APEX MAIN EMS STATION

6950 APEX BARBECUE ROAD, APEX, NORTH CAROLINA 27502 | WAKE COUNTY REQUEST FOR BIDS NUMBER: RFB-23-080

ADDENDUM NO. 3

DATE: OCTOBER 23, 2023

Excerpt from Drawing C3.1 – Utility Plan (Revision 4, Dated 09/25/23)

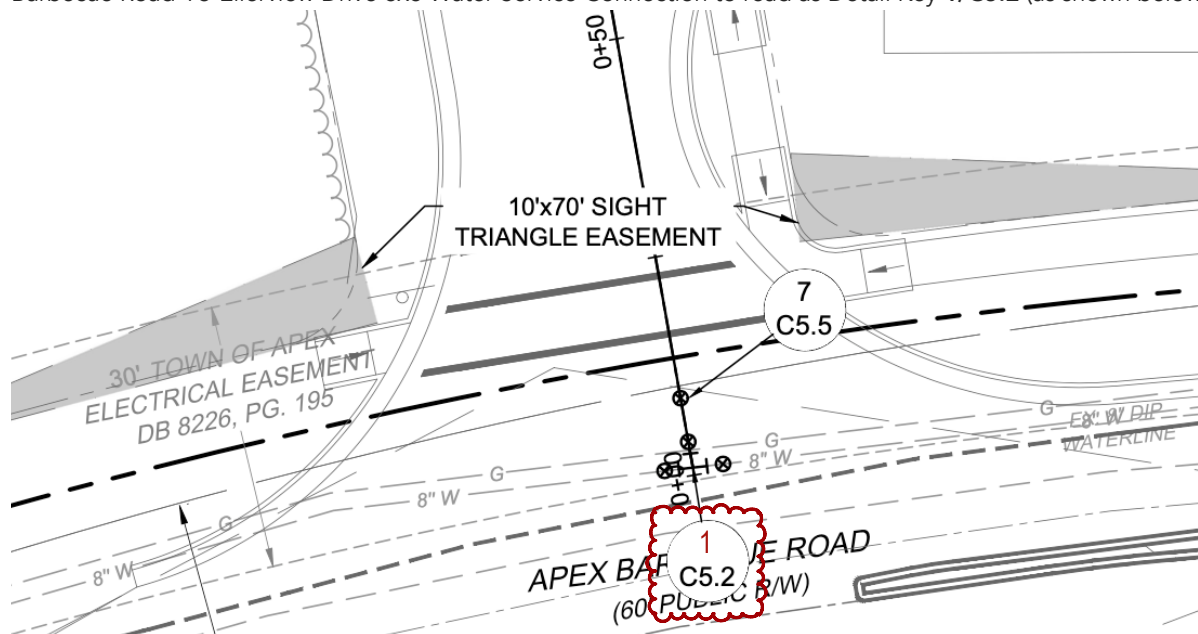
1. Apex Barbecue Road-To-Ellerview Drive 8x8 Water Service Connection: **REVISE** Detail Key 6/C5.2 at the Apex Barbecue Road-To-Ellerview Drive 8x8 Water Service Connection to read as Detail Key **1/C5.2** (as shown below).

2. Apex Barbecue Road-To-Ellerview Drive 8x8 Water Service Connection: **CLARIFICATIONS:**

- a. Town of Apex Water Utility will perform closing of existing valves to isolate a section of the 8" WL for the purpose of the 8" WL extension shown for this project.

- b. Town of Apex does not allow size-on-size taps. The required 8x8 water service connection will have to be accomplished by cut in of an 8" mechanical joint "Tee" with proper restraint per Town of Apex Specifications.

- c. The Town of Apex will not guarantee 100% shutdown. Contractor will be responsible for control of any residual water as needed.
- d. Per Town of Apex Specifications, the installation of the Tee and Valves should be organized to be completed in a maximum of four (4) hours.

- e. Per Town of Apex Specifications, all Waterline Pipe, Tee, and Valves shall be fully disinfected by swab method just prior to install.
- f. Per Town of Apex Specifications, only Town of Apex personnel will operate existing valves and perform needed flushing at completion of the install in order to place isolated section back into service.
